Tuesday, April 23, 2019
Public Meeting Room / Eagle Town Hall
200 Broadway Eagle, CO

- A. Application and Narrative
- B. Final Plat dated April 19, 2019
- C. Subdivision Improvement Agreement
- D. Ecological Restoration Plan ([LINK](#))
- E. Wetland Enhancement Plan ([LINK](#))
- F. Weed Management Plan ([LINK](#))
- G. Ownership and Maintenance Table
- H. Landscape Guidelines for Streetscapes
- I. Agency Referral Comments Summary
- J. Public Comment
- K. Planning and Zoning Commission Minutes – March 19, 2019

FINAL PLAT HAYMEADOW FILING 1 LOCATED IN TRACTS 37, 38, 44, 55, 59, 61, 62, AND 63, IN SECTIONS 2, 3, 4, 9, 10 AND 11, TOWNSHIP 5 SOUTH, RANGE 84 WEST OF THE SIXTH P.M. COUNTY OF EAGLE, STATE OF COLORADO SHEET 1 OF 13

FINAL PLAT
HAYMEADOW FILING 1
LOCATED IN TRACTS 37, 38, 44, 55, 59, 61, 62, AND 63, IN SECTIONS 2, 3, 4,
9, 10 AND 11, TOWNSHIP 5 SOUTH, RANGE 84 WEST OF THE SIXTH P.M.
COUNTY OF EAGLE, STATE OF COLORADO
SHEET 2 OF 13

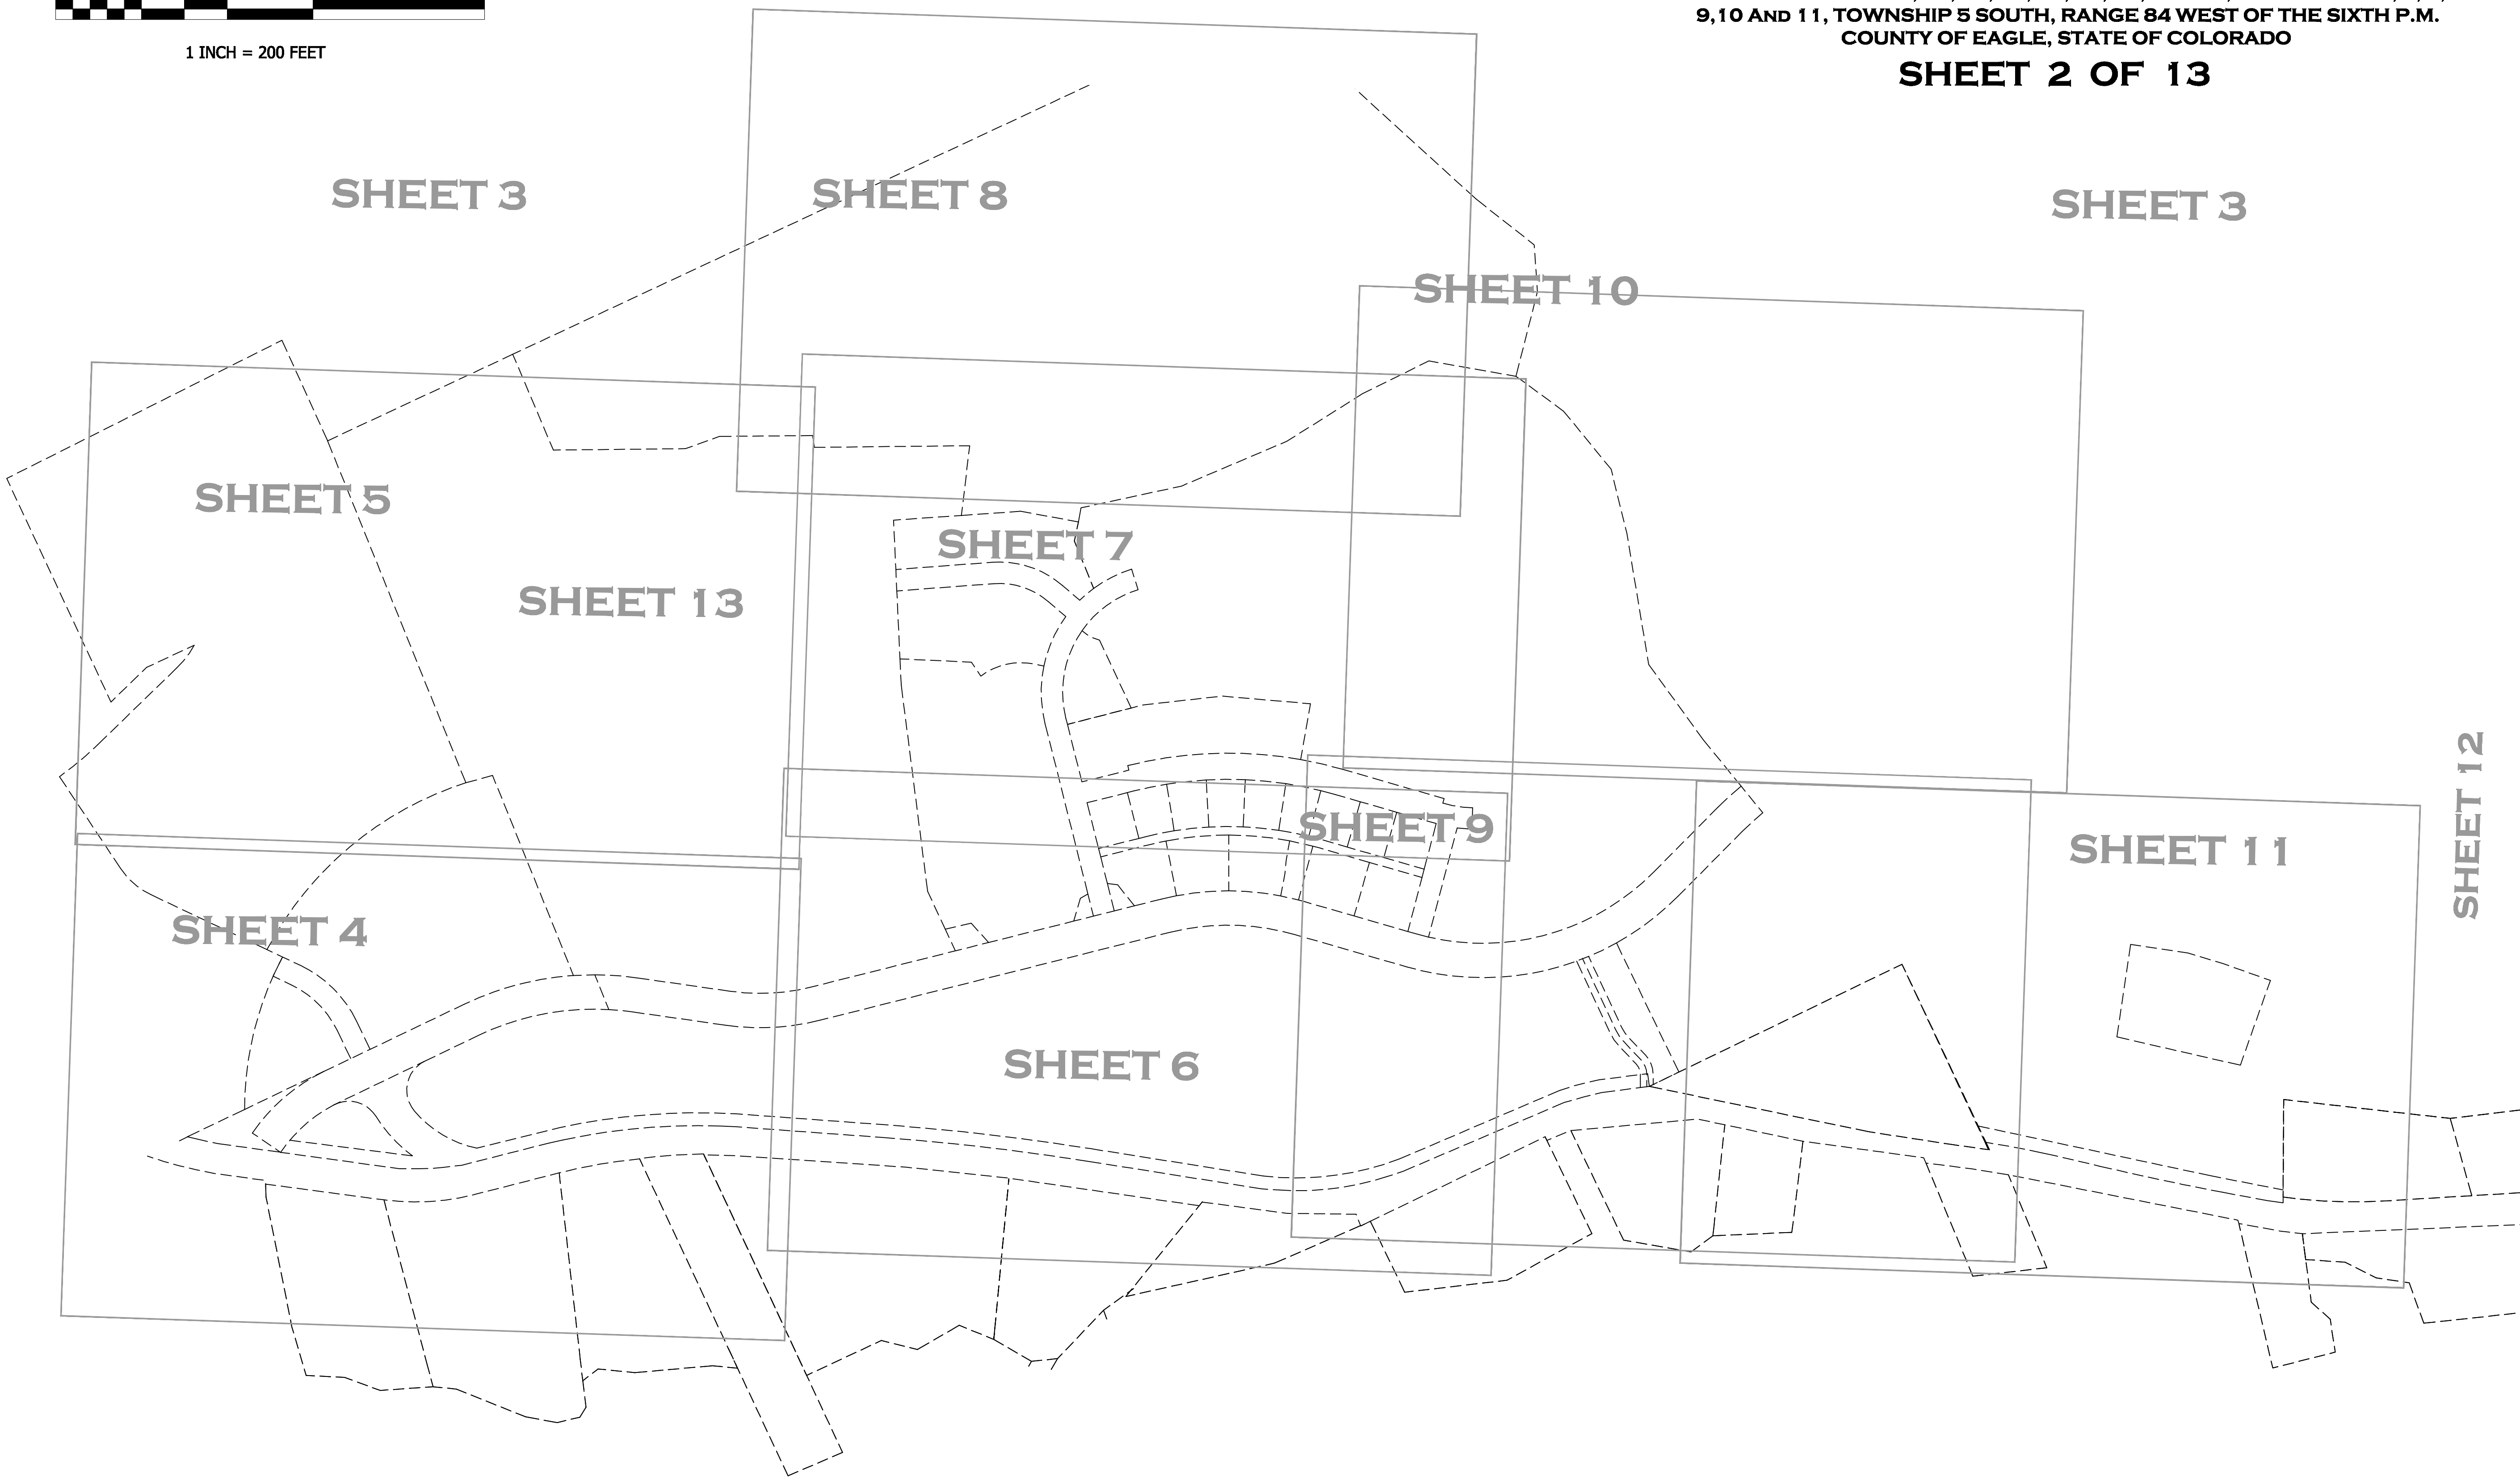
3. Sheet 2 of 10
 - a. The eastern boundary of OS-3 is different on the plat than on the Access and Infrastructure Plans. Staff would like to see the Final Plat document match the more straightforward orientation of the Access and Infrastructure Plans.

- 1. It would be helpful if Tracts 44, 55 and 63 were labelled and if Tract corners were labelled.
- 2. There is no Legend showing what symbols represent what types of corners were found or set.
- 3. On the West side of the property, the annotations follow the legal description on Sheet 1, but the boundary line shown goes around the Exception and is not annotated.
- 4. Monuments should be set on all boundary courses exceeding 1400 feet (38-51-105(c) C.R.S.)
- 5. Along the East boundary of the property three intermediate monuments are shown but are not dimensioned.
- 6. The annotation of 34.57' along the West line of Tract R-4 overlays linework and is difficult to read.
- 7. Several curves are non-tangential and should be labelled as such.

SHEET 6 OF 10

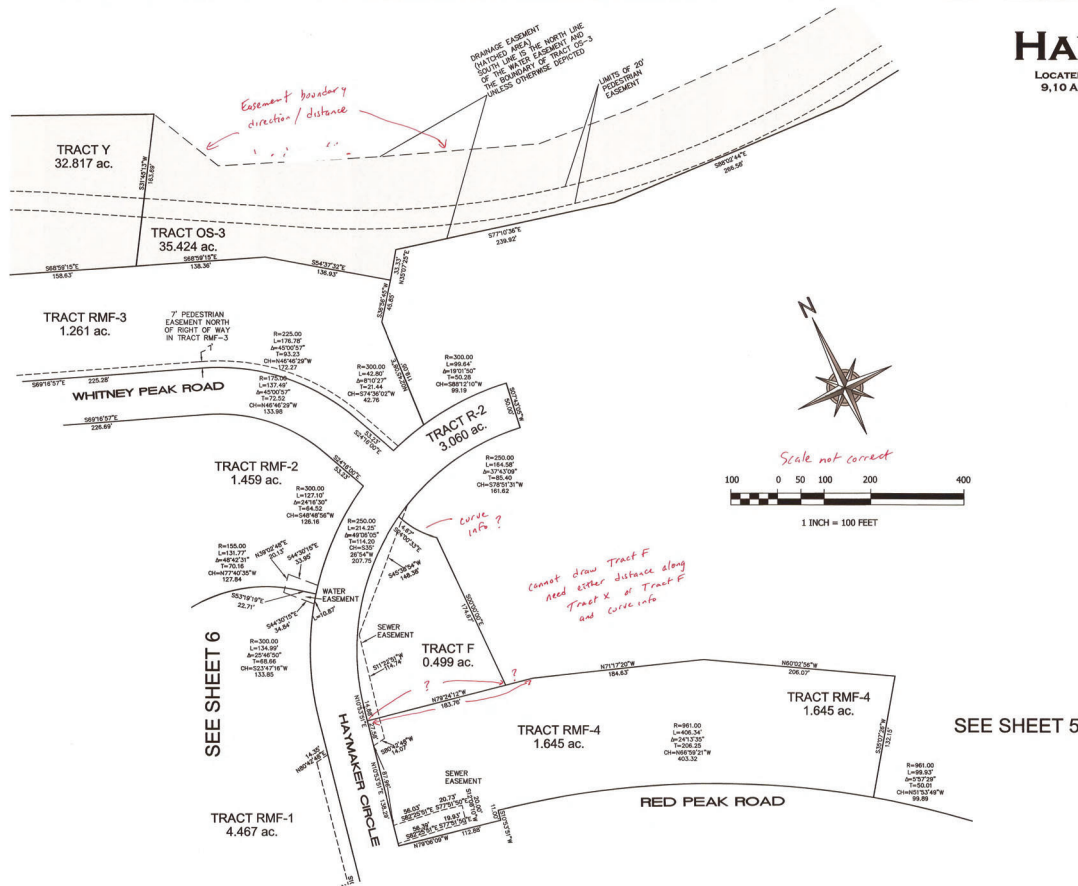
1. There is no annotation for the curve between Tracts F and X.
2. It is unclear to what the annotation of S24°00'33"E 4.67' pertains.
3. For Tracts F and X, I cannot calculate the individual areas as there is a curve on the boundary between the Tracts which is not annotated and indeterminate as to location.
4. For Tract RMF-1, see Comment 6, Sheet 4.

5. See Comment 2, Sheet 4.
6. There should be a tie to the northerly terminus of the sewer easement on the easterly line of Haymaker Circle.
7. There should be a tie to the northerly terminus of the sewer easement on the westerly line of Haymaker Circle.
8. The annotation for the curve with a delta of $45^{\circ}00'57''$ and radius of 175.00' overlays linework and is difficult to read.
9. The label "SEE SHEET 6" should be "SEE SHEET 4".

FINAL PLAT
HAYMEADOW FILING 1
 LOCATED IN TRACTS 37, 38, 44, 55, 59, 61, 62, AND 63, IN SECTIONS 2, 3, 4,
 9, 10 AND 11, TOWNSHIP 5 SOUTH, RANGE 84 WEST OF THE SIXTH P.M.
 COUNTY OF EAGLE, STATE OF COLORADO
SHEET 8 OF 10

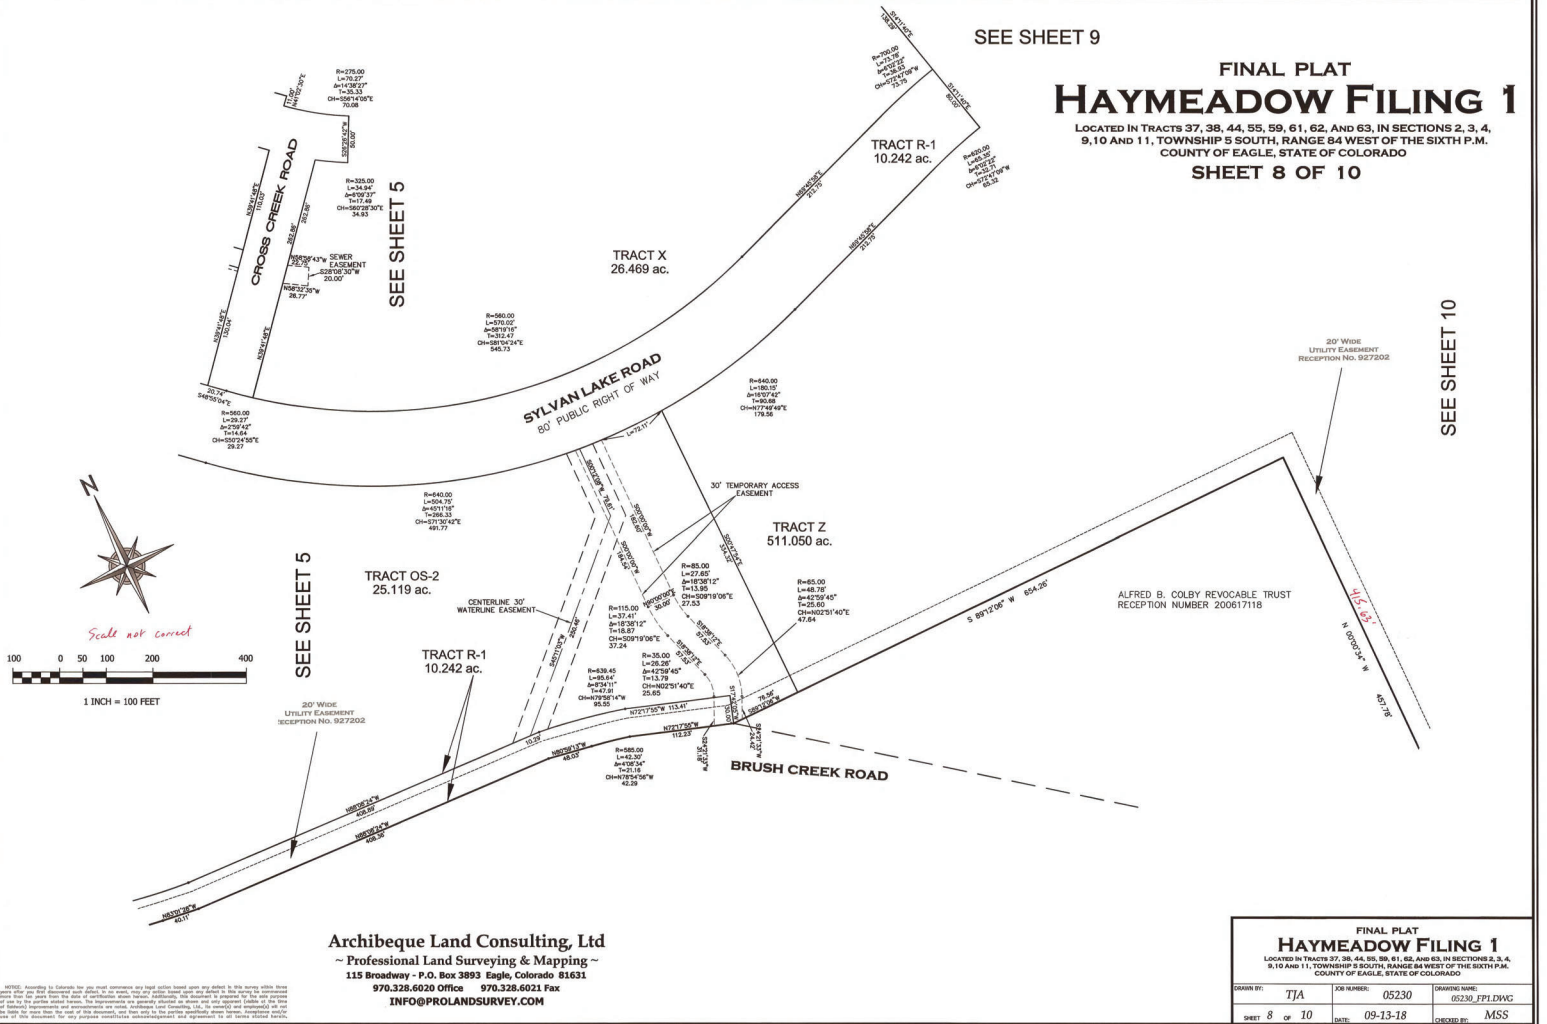
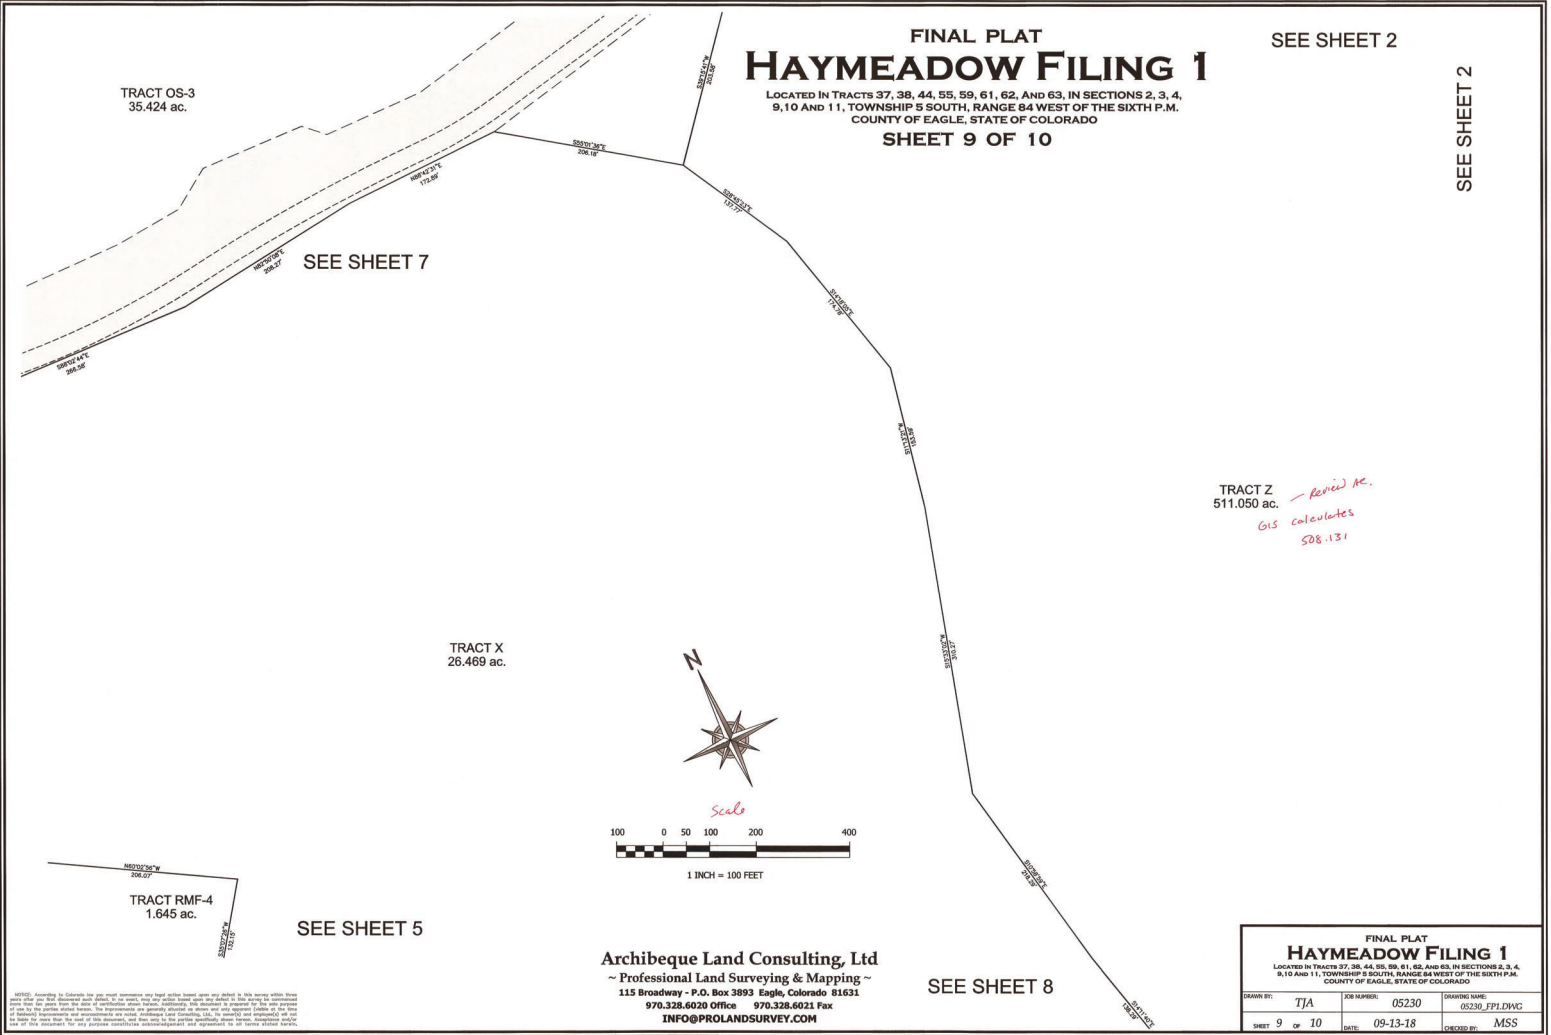
1. See Comment 20, Sheet 5.
2. For Tract OS-2, see Comment 7, Sheet 3.
3. For Tract R-1, see Comment 9, Sheet 3.
4. For Tract X, see Comment 1, Sheet 6.
5. For Tract Z, see Comment 4, Sheet 7.
6. The curve on the line between Tracts OS-2 and R-1 with a delta of $8^{\circ}34'11''$ is non-tangential and should be so labelled.
7. The annotation for the temporary access easement of $S24^{\circ}21'33''$ 24.42' overlays linework and is difficult to read.
8. There is no tie for the southerly terminus of the temporary access easement.
9. There is no tie for the northerly terminus of the waterline easement.
10. The waterline easement does not appear to close on Sylvan Lake Road.
